CONSTRUCTION PLANS
FOR

NORTH VALLEY AREA I PHASE 2 AND AREA J SEWER PROJECT CABALLERO NORTE GRAVITY SYSTEM

Acknowledge receipt
APPROVAL OF RECORD DRAWINGS
CHIEF CONSTRUCTION ENGINEER
DATE 3/02/2007

REV.	SHEETS	CITY ENGINEER	DATE	USER DEPARTMENT	DATE	USER DEPARTMENT	DATE
1	All	AS-BUILT	11/16/06				
ENGINEERS STAMP & SIGNATURE				APPROVALS	ENGINEER	DATE	* * * * *
				DRC Chairman	William J. Balch	9-28-05	APPROVED FOR CONSTRUCTION
				Transportation	William J. Balch	9/28/05	
				Water/Wastewater	William J. Balch	9/14/05	
				Hydrology			
				C.I.P.			
				Constr. Mngmt.			City Engineer
				Constr. Coord.			
				City Project No.		763581	Sheet 1 of 17/19

TITLE:	NORTH VALLEY AREA I PHASE 2 & AREA J SEWER PROJECT CABALLERO NORTE GRAVITY SEWER SYSTEM VILLAGE BARN PLAN AND PROFILE STA 14+00 TO 17+50
--------	--

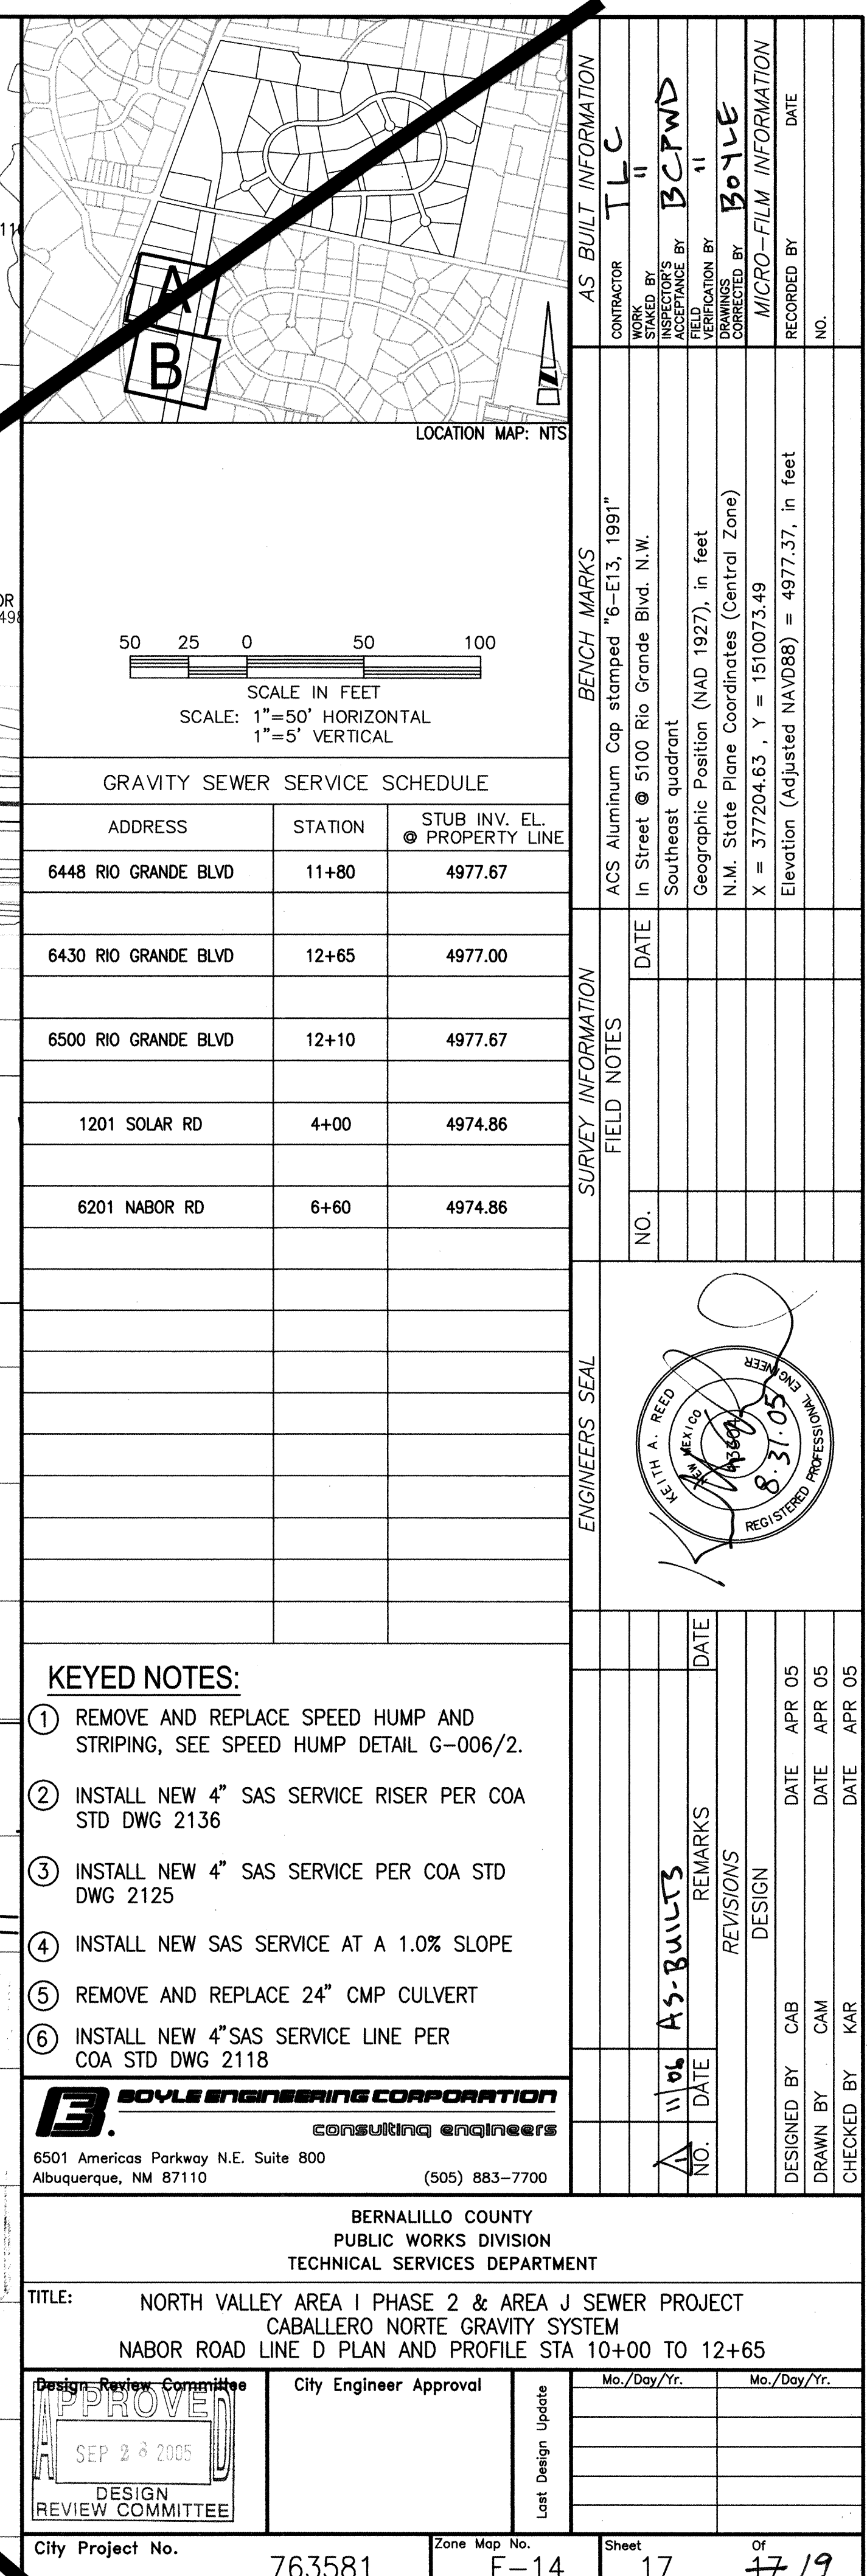
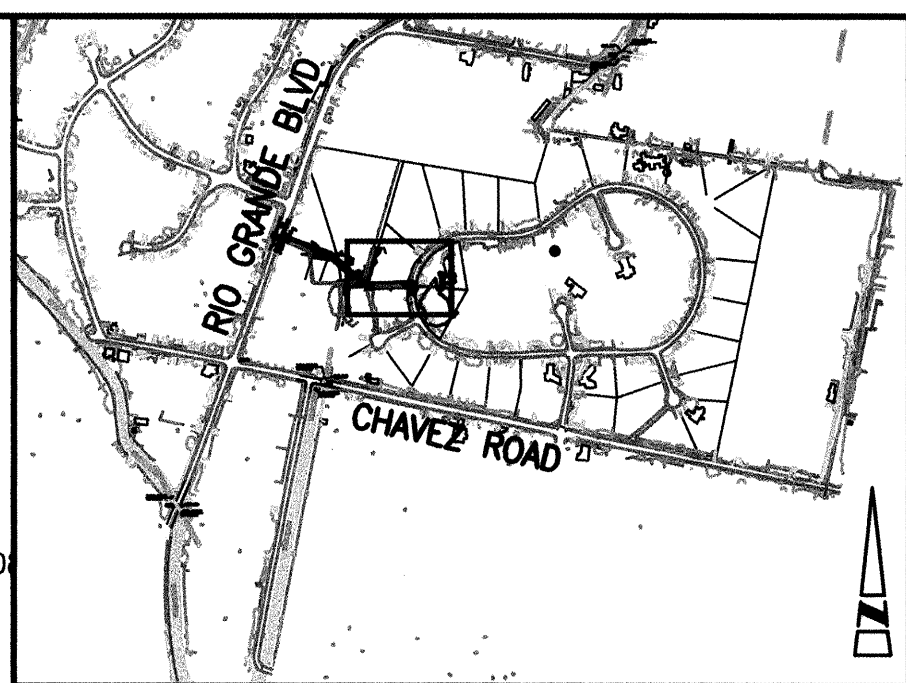
~~☒ BORE AND JACK NEW 14" STEEL CASING, L = 45 LF±. INSTALL NEW 8" CARRIER PIPE INSIDE CASING PIPE INCLUDING CASING END SEALS AND SPACERS, L = 55 LF±.~~

~~☒ BORE AND JACK NEW 12" STEEL CASING, L = 45 LF±. INSTALL NEW 8" CARRIER PIPE INSIDE CASING PIPE INCLUDING CASING END SEALS AND SPACERS, L = 55 LF±.~~
